### Proposed Revisions to a Standard Plans Index

Index Number: 425-001

Index Title: Supplementary Details for Drainage Structures

**TABLE OF CONTENTS:**

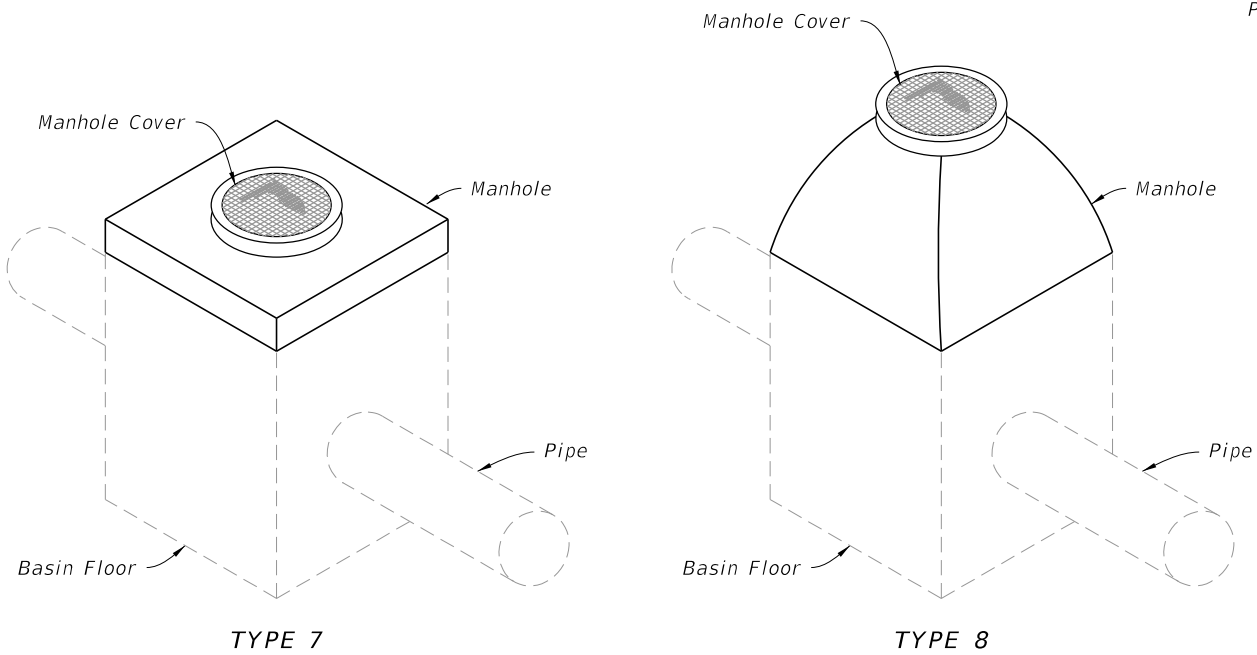
Sheet 1: Updated the Table of Contents to reflect title change on Sheet 3.

UPDATED TITLE: Geotextile

PIPE TO STRUCTURE FILTER FABRIC WRAP

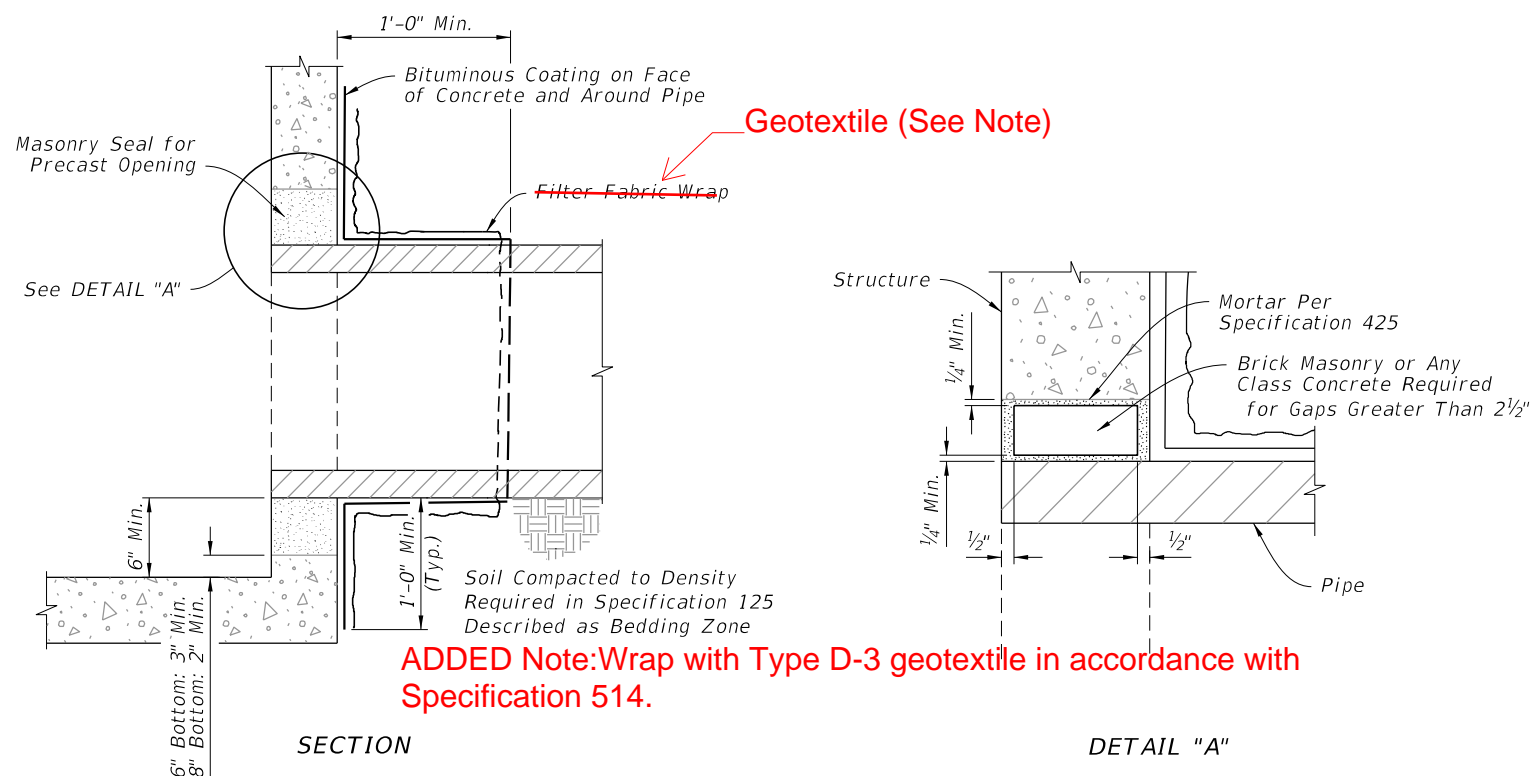
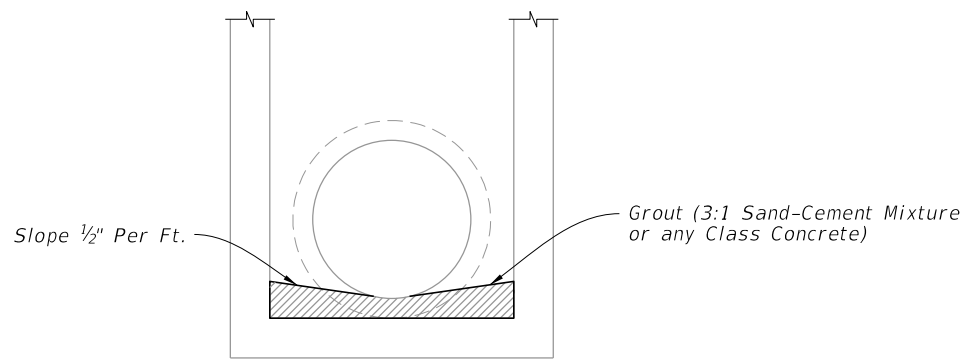
Sheet 3: Added Note "Wrap with geotextile in accordance with Specification 514." to the PIPE TO STRUCTURE FILTER FABRIC WRAP detail; Changed all references of "Filter Fabric" to "Geotextile".

Wrap with Type D-3 geotextile in accordance with Specification 514.

**SUMP BOTTOM**

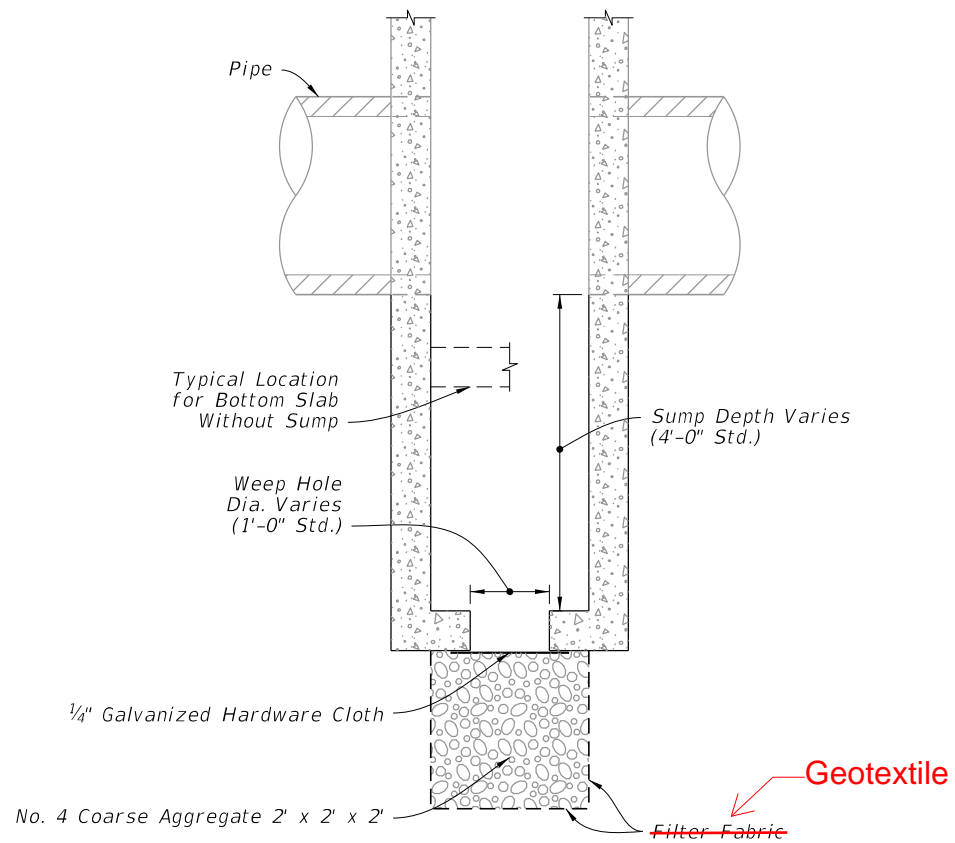
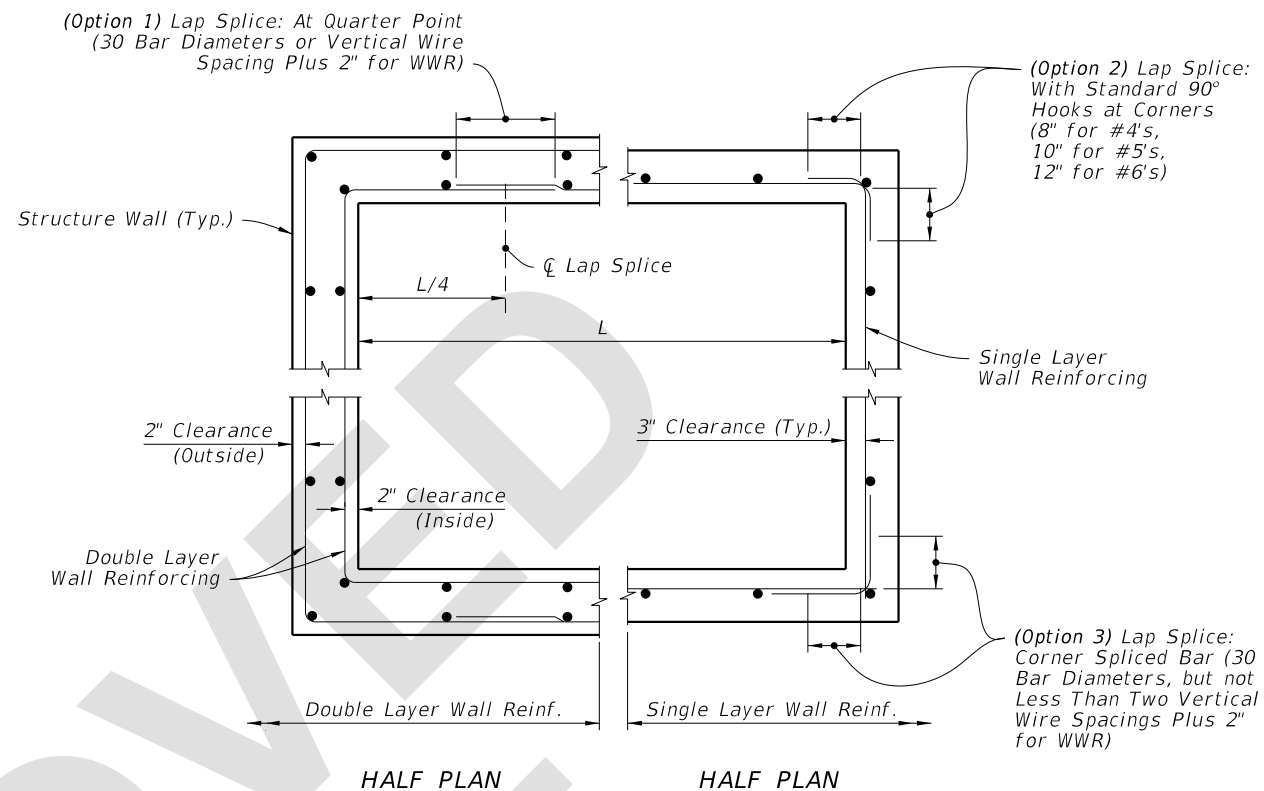
Sheet 4: Added Note 4 "Install Type D-3 geotextile in accordance with Specifications 514." to the SUMP BOTTOM detail.; Changed all references of "Filter Fabric" to "Geotextile".

**Note 4: Install Type D-3 geotextile in accordance with Specifications 514.**

1. Construct sumps in inlets and manholes connecting to French Drains unless excluded in the Plans.
2. Construct sumps only where called for in the Plans at all other locations.
3. Construct weep holes in sump bottom only where called for in the Plans.
4. Install Type D-3 geotextile in accordance with Specification 514.
